**CONTINUING ELIGIBILITY INSPECTION (CEI) REPORT  
FOR HURRICANE & SHORE PROTECTION PROJECTS**

1. Project Name: Aoa Shore Protection Project

2. Date of Inspection: April 9, 2002

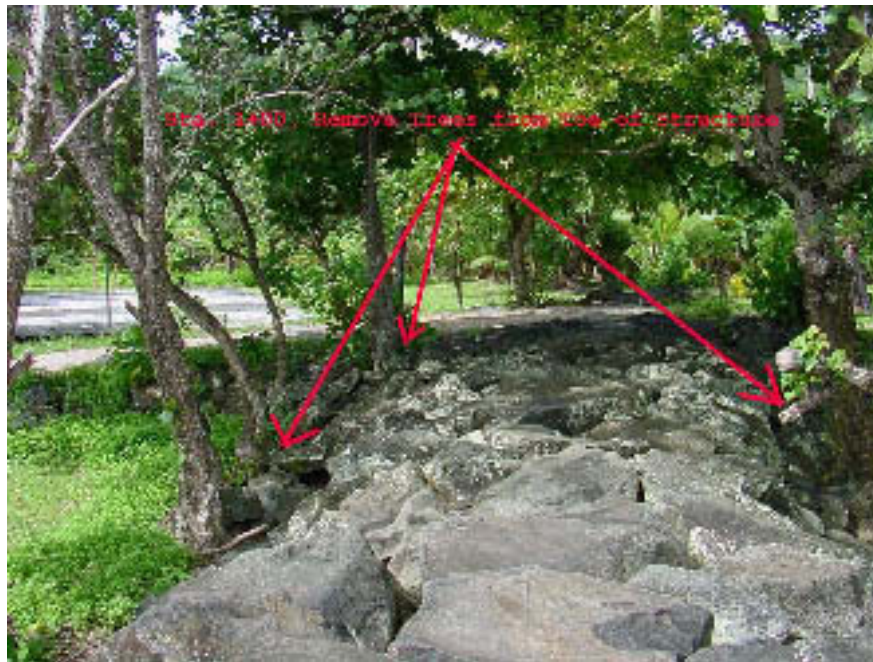
The SPP is 670 LF. Sta. 0+00 is located at the West-End of the project (Opposite the Main Road Side). All discrepancies were noted and brought to the representative's attention. The major deficiencies were as follows:

a. Sta. 0+00, End of west tieback, remove trees.

b. Sta. 0+20, Remove tree from front toe of structure.

c. Road built over the revetment (no problem).

d. Sta. 1+00, Remove vines from structure.

e. Sta. 1+20, 1 split armor stone at the toe.

f. Sta. 1+20, 3 ea. dislodged armor stones at the backside.

g. Sta. 2+20, Remove juvenile tree from structure.

h. Sta. 3+70, Monitor void / bridging thru structure.

i. Sta. 3+20 - 3+70 Monitor bridging of armor stones, (large tree has been cut on the interior side), slight depression thru crest and down the sideslope.

j. Sta. 3+25, Remove coconut tree.

k. Sta. 3+70, Split armor stone, monitor sideslope depression.

l. Sta. 2+70 - 4+70, Monitor sideslope settling.

- m. Sta. 4+70, the big tree has been cut, however continue to monitor dislodged armor stones and monitor bridging and sideslope depression.
- n. Sta. 5+20 - 5+70, 2 split armor stones on the sideslope, monitor bridging.

- o. Sta. 5+65, Monitor slight depression at the sideslope / crest hinge.

- p. Sta. 5+90, Remove trees and other vegetation from structure.

p. Sta. 5+95, Monitor armor stone. Stone is in place (or the existing armor stone has been repositioned) but not keyed or fitted. Loss of contact and bridging at the tie-in to the culvert wing wall. Loose stones at the toe (results of construction of the 13' x 5' box culvert in the adjacent stream).

q. Sta. 6+00 - 6+50, A road is built through the revetment. Request COE's review prior to actions of this sort.

r. Sta. 6+50 - 6+70, Remove vegetation from revetment.

s. Sta. -1+00 - 6+70, (upstream of the east tieback) Monitor the steel sheetpiles protecting the inner tieback. Note: The sheetpile is not part of the authorized project.

The focus of the maintenance required should be directed at vegetation control. Removal or herbicides are recommended in lieu of cutting.
